# TOWN OF GLASTONBURY

GL-2023-12

## FIRE HOUSE IMPROVEMENTS

ADDENDUM NO. 4

**PL1**

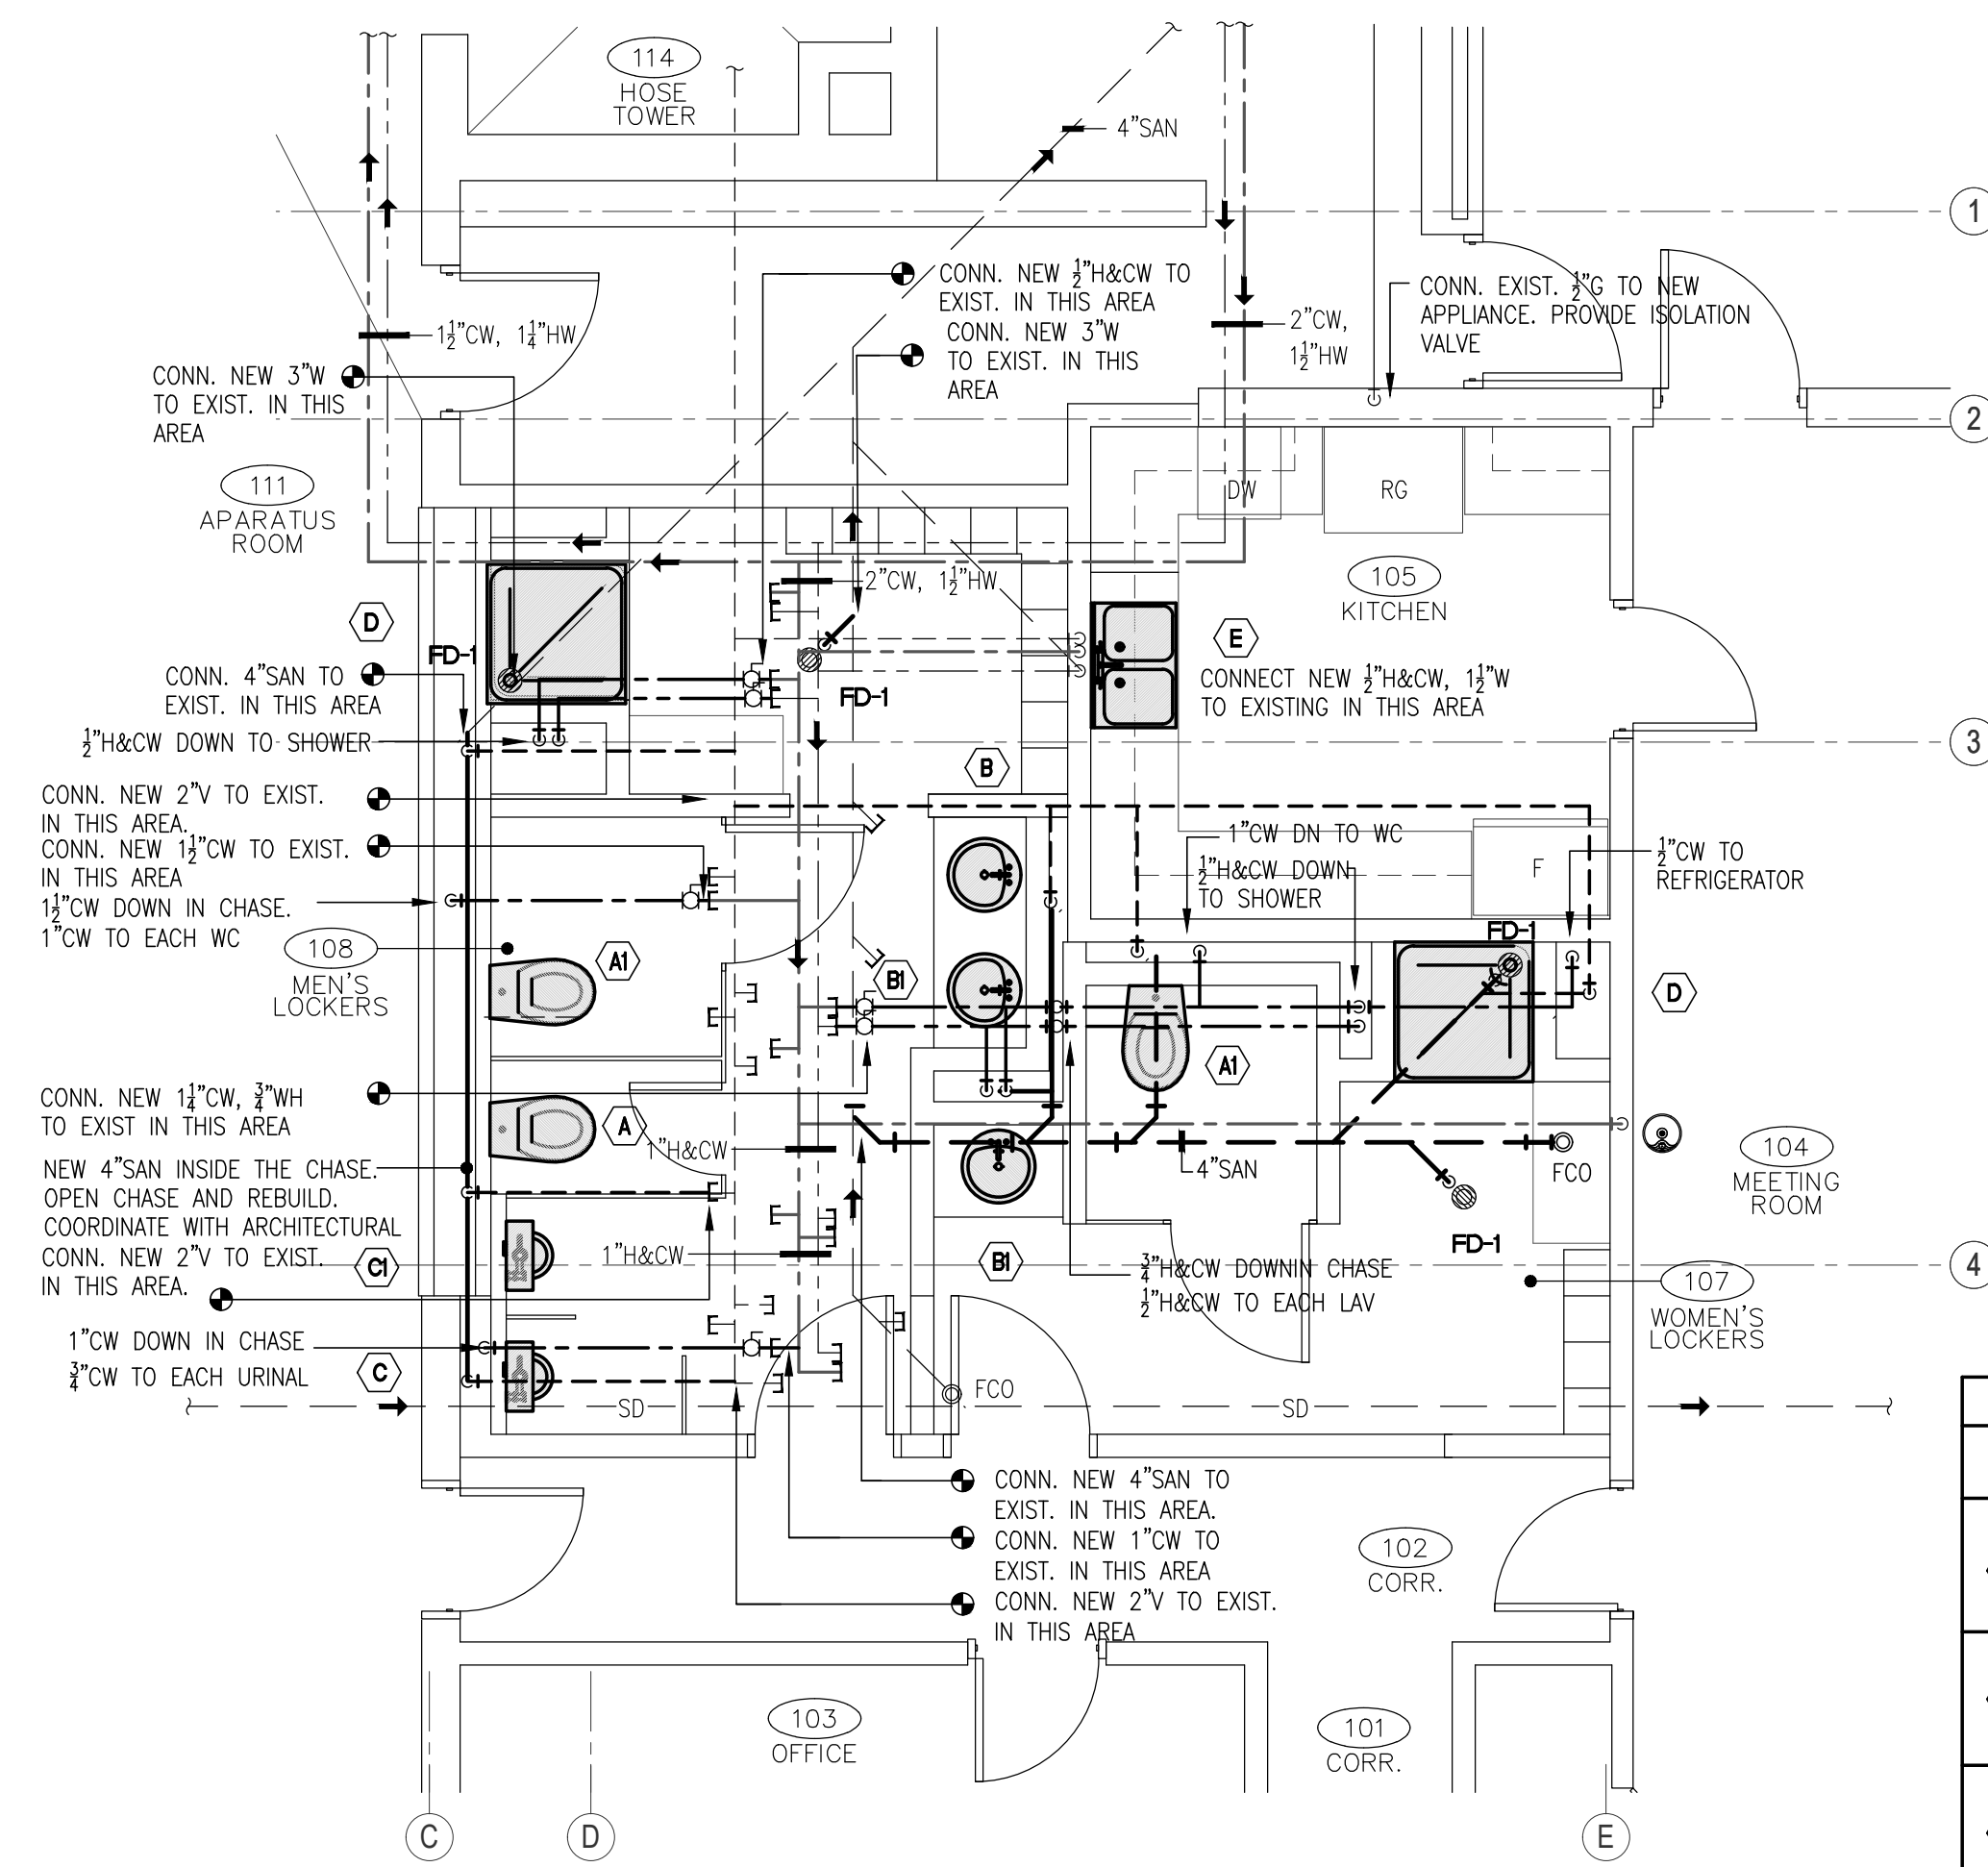
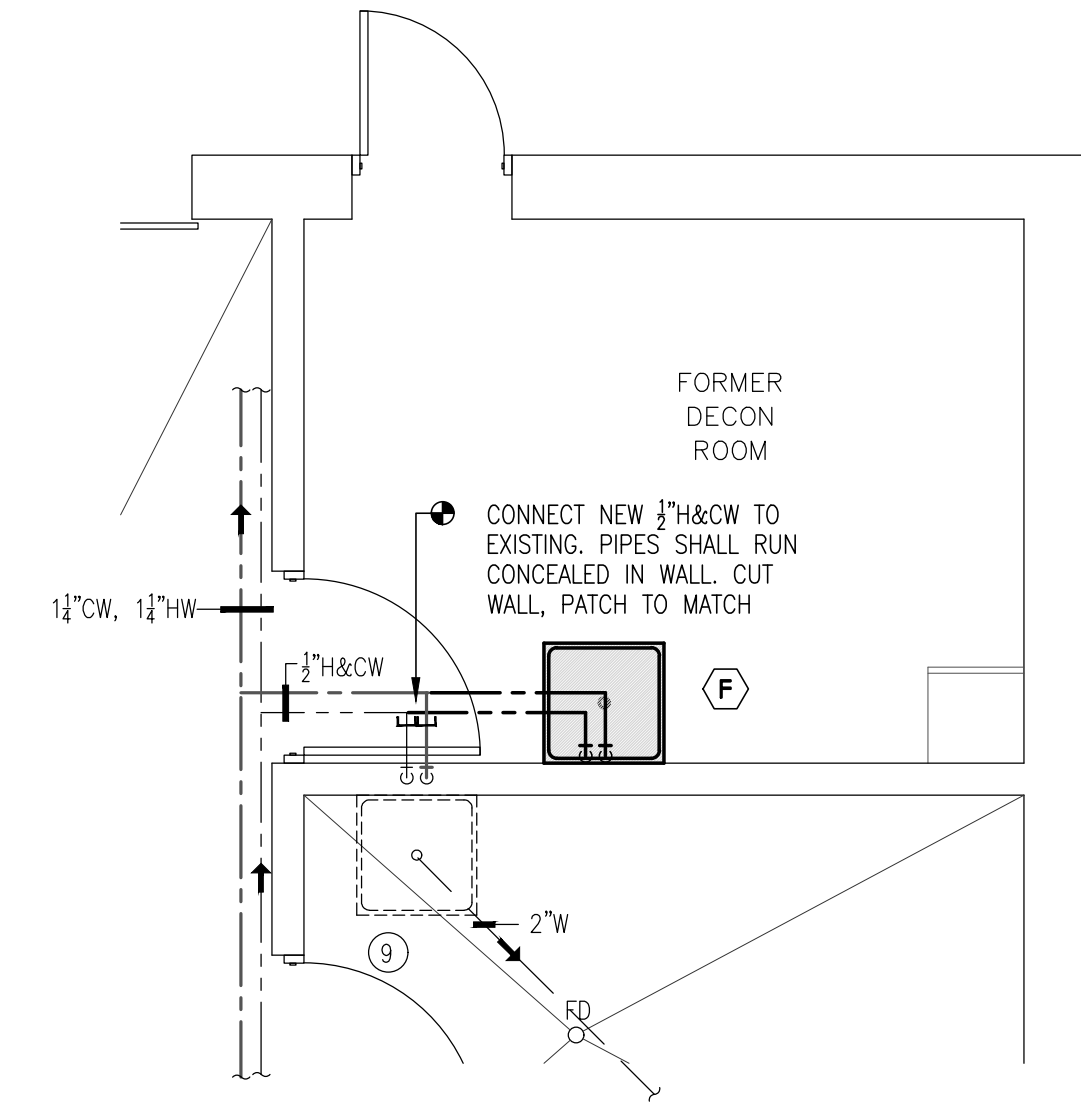
**Question 35:** *Please clearly define the extent of the plumbing work the contractor is responsible for.*

**Answer:** See Drawings M1, E1, PL1 and FP1
